**RESPONSES TO EPA TECHNICAL MEMORANDUM DATED 5 FEBRUARY 2004  
ON THE SITE 16 QAPP FOR HRC INJECTION PILOT STUDY OF SEPTEMBER 2003  
NAVAL CONSTRUCTION BATTALION CENTER DAVISVILLE  
NORTH KINGSTOWN, RHODE ISLAND**

EFANE  
SITE 16 HRC INJECTION PILOT TEST  
FORMER NCBC DAVISVILLE FACILITY  
NORTH KINGSTOWN, RHODE ISLAND

### SITE MAP

DESIGNED BY JAS	DRAWN BY RWC	DATE 2/20/04	PROJECT NO. 2960107	FILE NAME FIG 5
CHECKED BY RWC	PROJECT MGR. JAS	SCALE AS SHOWN	DRAWING NO. -	FIGURE Figure 5A

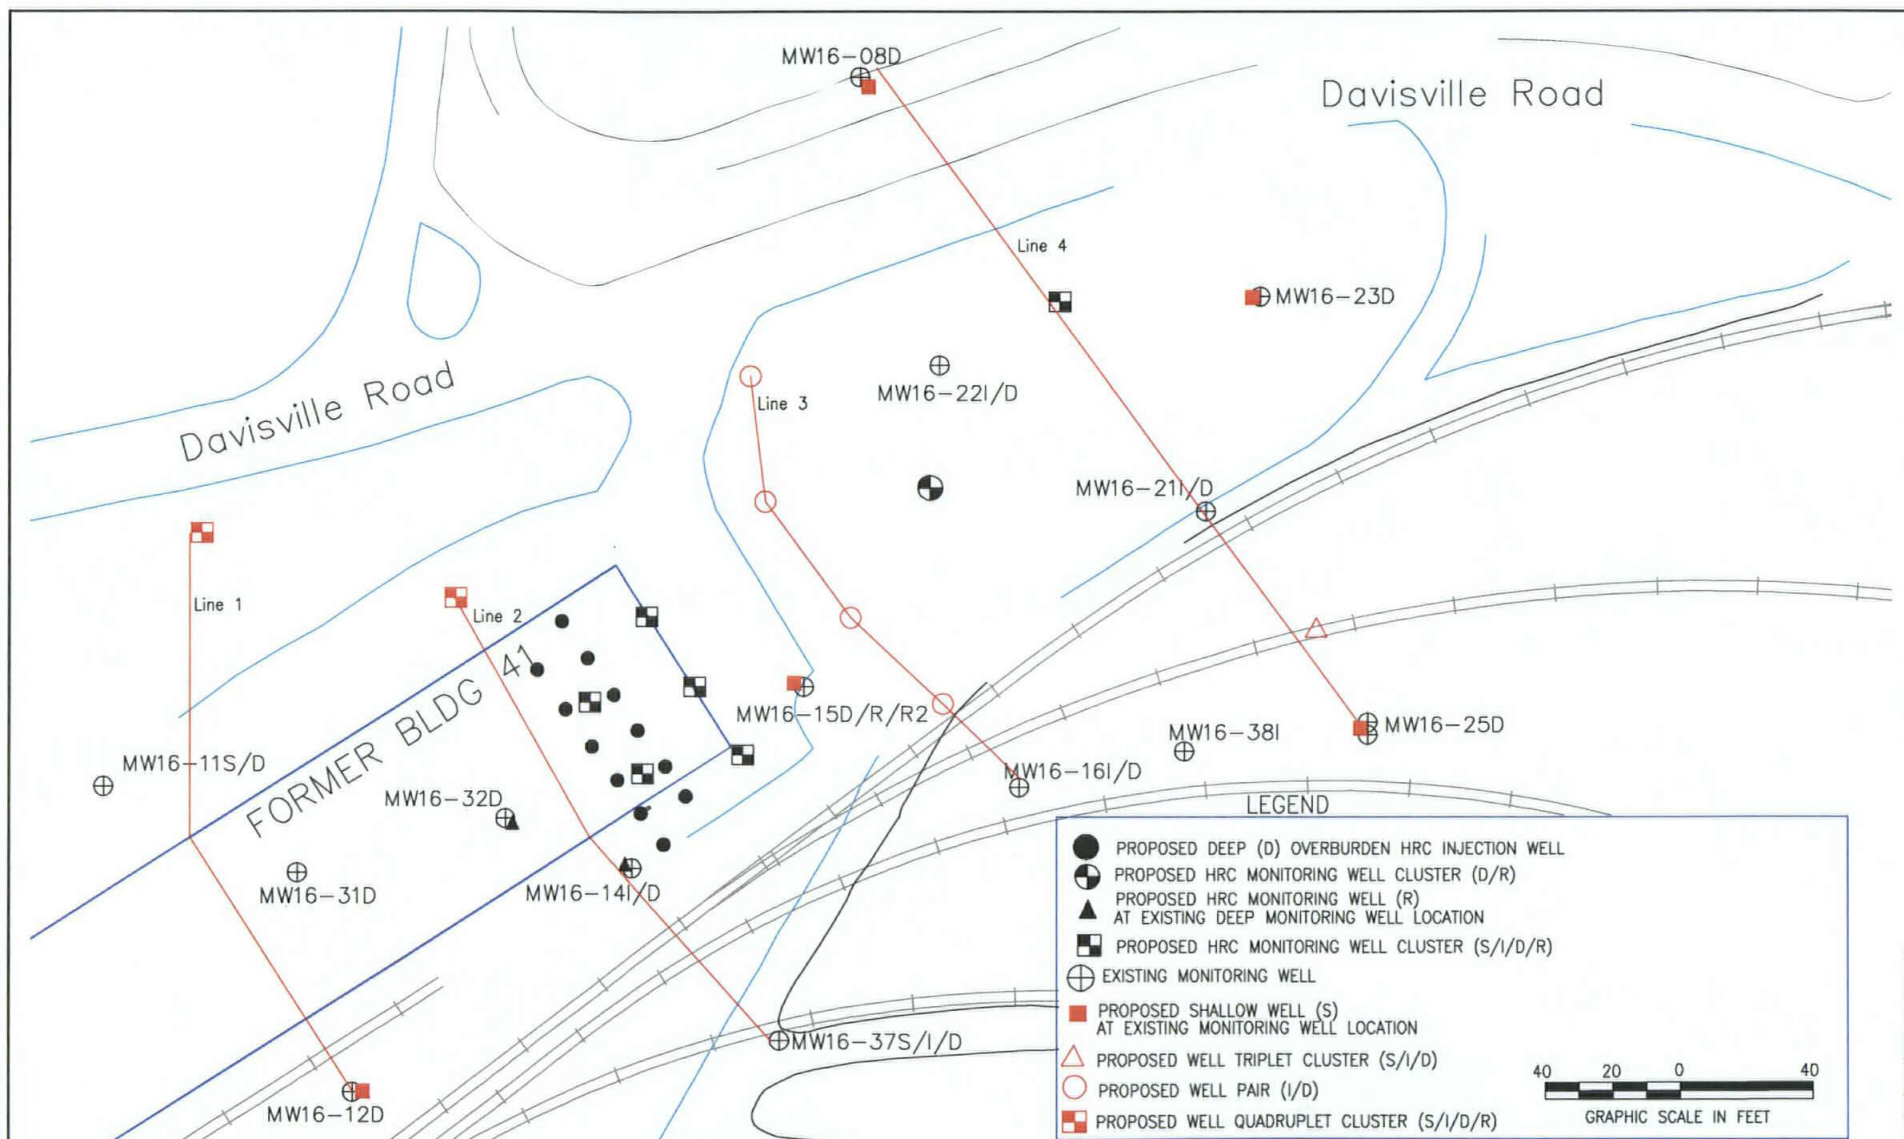
1. Background monitoring locations must not be impacted by significant contributing contaminant levels that might affect the observed results of the pilot test. The background or "up gradient" monitoring wells proposed in the pilot study are not background wells and therefore, do not fulfill this objective. A true up gradient background line of wells should be established. This line should consist of the wells at locations MW16-12, MW16-31, MW16-11, and a new well quadruplet north of the former Building 41 location and just south of Davisville Road. This is shown as Line 1 on the attached figure.

2. The Navy should also gather shallow groundwater data at the available shallow wells at locations MW16-33 and MW16-34. If these are not planned to be included in the groundwater sampling program then Navy should install a shallow well at the MW16-12 location to tighten up-gradient control.

3. The wells referred to in the pilot study work plan as "background wells" are actually source area wells, not background wells. That is, MW16-14D and MW-32D exhibit high levels of chlorinated volatile organic contamination. Monitoring of those wells is acceptable if used for the first purpose, source area monitoring, keeping in mind that there has not been a delineation of the inferred source area described in the pilot study work plan. Specifically, there is a data gap to the north side of the former Building 41 footprint.

4. Also, MW16-37S/I has been shown to be a major potential contributing source area that could impact groundwater quality in the down gradient area of the pilot test and mask results.

In order to fully assess this "source area," a line of wells including MW-37S/I/D, MW16-14D, MW16-32D, and a new monitoring well quadruplet installed on the north side of the former Building 41 footprint is needed. This is shown as Line 2 on the attached figure. EPA agrees with the Navy's original proposal to add rock wells to locations MW16-32 and MW16-14 to further expand our understanding of the bedrock system in this source area, however, would be willing to negotiate the removal of these proposed rock wells for this pilot study due to the focus of the pilot study being in the overburden.

5. Several proposed groundwater monitoring wells are proposed within and immediately adjacent to the HRC® pilot injection points. These wells are interpreted by EPA to be process monitoring wells, rather than down gradient monitoring wells. The first line of true near-term down gradient monitoring wells is interpreted to be the line of four proposed well locations that align with MW16-16 I & D. However, these wells are not optimally positioned due to the uncertainties in groundwater flow patterns from the area of HRC® injection. Therefore, it is recommended that the positions of those wells be adjusted as shown on the attached figure. Those wells, along with MW16-16 I & D constitute Line 3. No additional new well locations are required for this line. EPA requests that these proposed well clusters to consist of intermediate and deep wells rather than deep and rock wells since the pilot study focus has changed from the bedrock system to the deep overburden.

6. A second line of down gradient monitoring is necessary to evaluate groundwater quality changes resulting from the proposed pilot study. This line is shown on the attached figure as Line 4. It consists of existing monitoring wells MW16-25D, MW16-21I and D, MW16-23D, and MW16-08D along with augmentation by two additional well clusters already proposed. The two wells located down gradient of the Line 3 wells, should be shifted as shown on the attached figure. One should be moved to between MW16-23D and MW16-08D, just south of Davisville Road and the other to between MW16-21D and MW16-25D. No additional well locations are required for this line. The well clusters should consist of shallow, intermediate, and deep well screens.

7. Shallow groundwater flow patterns are not resolved up-gradient, at, nor down gradient of the proposed pilot test. Therefore, EPA believes it is necessary to construct a shallow monitoring well at MW16-15D, MW16-08, MW16-23D, and MW16-25D to complete resolution of down-gradient shallow groundwater flow patterns and assist in monitoring of shallow groundwater quality. In the previous paragraphs EPA has requested either a shallow well screen be installed at the MW16-12 location or that MW16-33 S and MW34S be included for gauging as part of the pilot test. Additionally, the two new monitoring well locations north of former Building 41 have been requested to have shallow well screens installed.

**Response:** The Navy agrees with this 'Line 1' of monitoring wells as shown on the attached figure. However, some of the existing wells were not accurately located on the figure provided by EPA, the locations for EPA's additional or moved wells were added to the CAD file for this drawing so that the existing monitoring wells plot in their proper locations. The monitoring well locations, which were added or moved by EPA, are shown by 'red' colored symbols. The additional monitoring well location was generally agreed to during the 12 December 2003 BCT meeting. However, it is assumed that the actual location of the added well quadruplet can adjusted in the field so it is not within the relatively new storm water retention pond in that area, but rather located south of Davisville Road and north of the existing chain-link fence.

**Response:** The Navy plans to install and sample a shallow well at the MW16-12 location.

**Response:** The Navy agrees with this 'Line 2' of monitoring wells. The additional monitoring well location was generally agreed to during the 12 December 2003 BCT meeting. However, it is assumed that the actual location of the added well quadruplet can be adjusted in the field to lessen its impact on that area where new cars are parked.

**Response:** Two of the 'process monitoring' well quadruplets have been deleted so those resources can be used at the 2 new well quadruplet locations (Lines 1 and 2). The Navy agrees with the minor shifting of the proposed monitoring wells along Line 3 with the following minor revision: move the southern 2 proposed monitoring wells each 5-10 ft northwest along Line 3 for better coverage of the migration of the main plug of the injected HRC® and so the southern of these 2 well pairs is a minimum of 10 ft from the railroad tracks.

**Response:** The Navy agrees with this 'Line 4' of monitoring wells with the following suggestions: 1) MW16-25 will be used in lieu of the southernmost of EPA-proposed well triplets because it is too close to MW16-25 to be cost effective, and 2) the installation of a rock (R) well to northern proposed well triplet (now a quadruplet) location so the potential downward migration from the injection interval (deep overburden) can be assessed. The rock well will also provide important vertical hydraulic gradient data between the deep overburden and the upper bedrock zones. Additionally, the Navy believes that a deep overburden and upper bedrock monitoring well pair is still appropriate to be located between Lines 3 and 4 so the migration of the HRC® can be tracked along the length of its interpreted flow path approximately midway from the nearest rock monitoring well toward both the northeast and southwest directions.

**Response:** The Navy agrees with the installation of the 4 shallow monitoring wells. Please see the Navy's responses to EPA Comment No. 2 regarding MW16-12 and EPA Comment Nos. 1 and 4 regarding the two new monitoring well locations north of former Building 41.
